NUREG-0574

environmental statement

**related to selection of the
Preferred Closed Cycle
Cooling System at**

INDIAN POINT UNIT NO. 3

FIG. 3-1

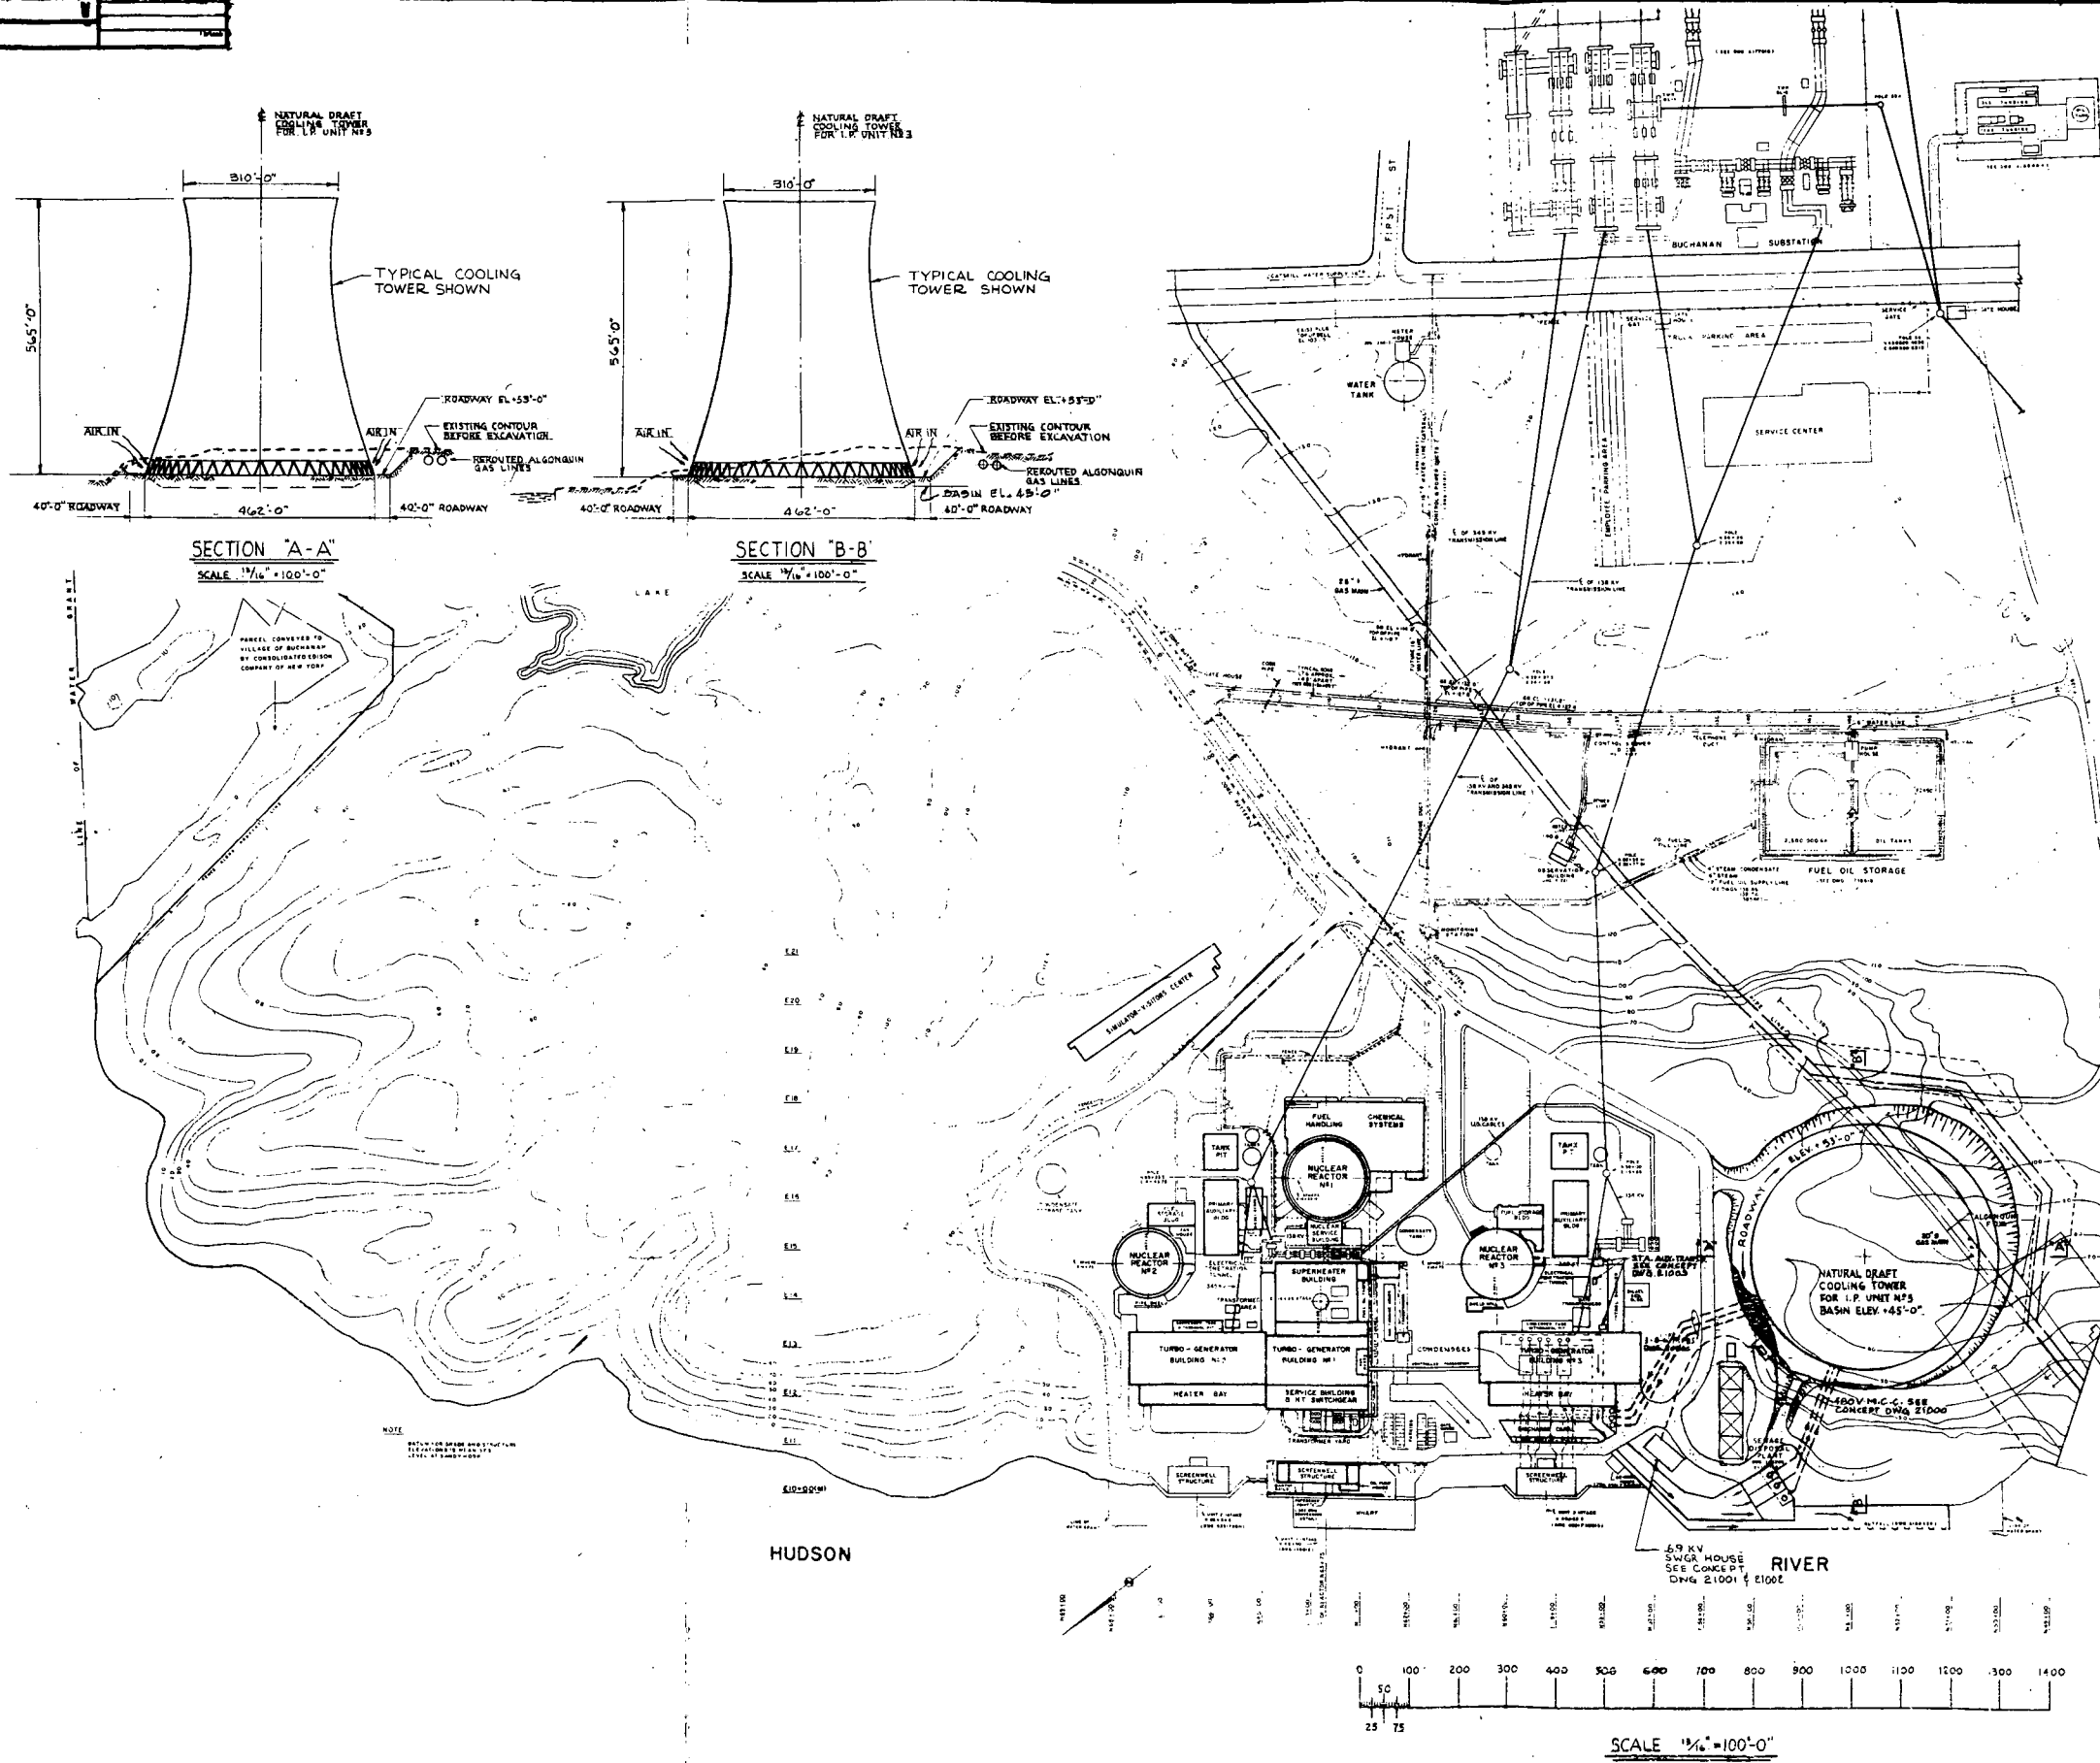
§ 3.4.5, ¶2. As shown in Figure 3-1, the proposed natural draft cooling tower is located relatively close to the plant because of the proximity to the south property line which restricts the physical arrangement. Thus, the tower would be less than a tower height away from the Indian Point 3 containment,

FIGURE 5-1

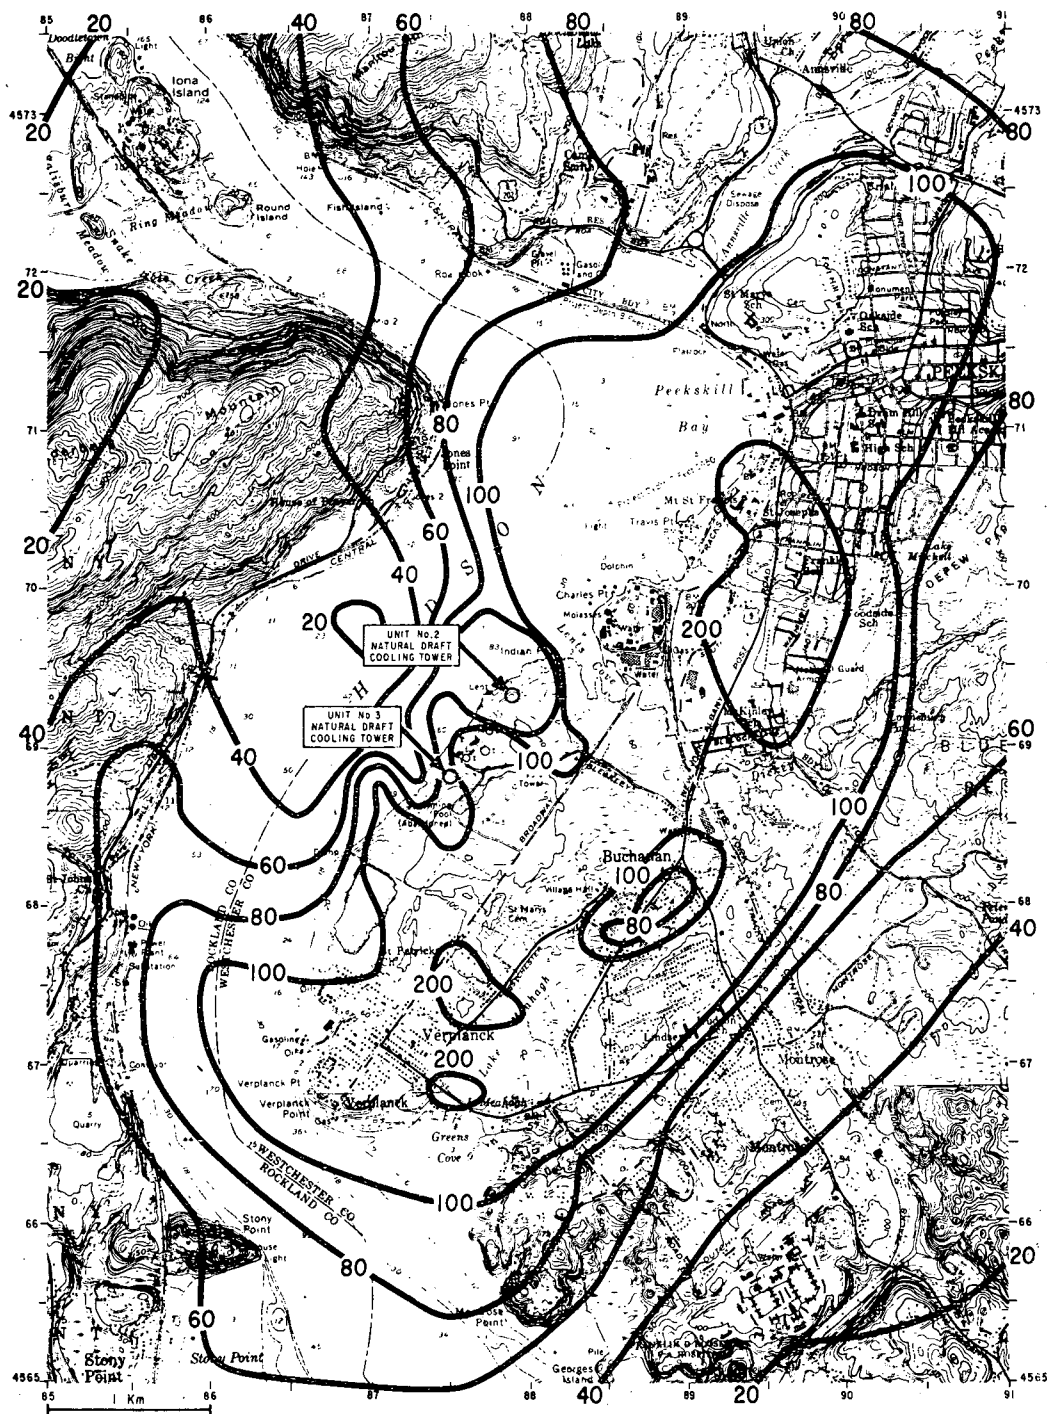
It is stated that the highest NDCT off-site salt deposition rate was found by the applicant to be 350 kg/km²/month (about 3 lb/acre/month). However, Figure 5.1 (Ref: ER - cc - 3, Fig. 6-5) shows the maximum isopleth to be 200 kg/km²/month. There should have been at least a 300 isopleth in this figure.
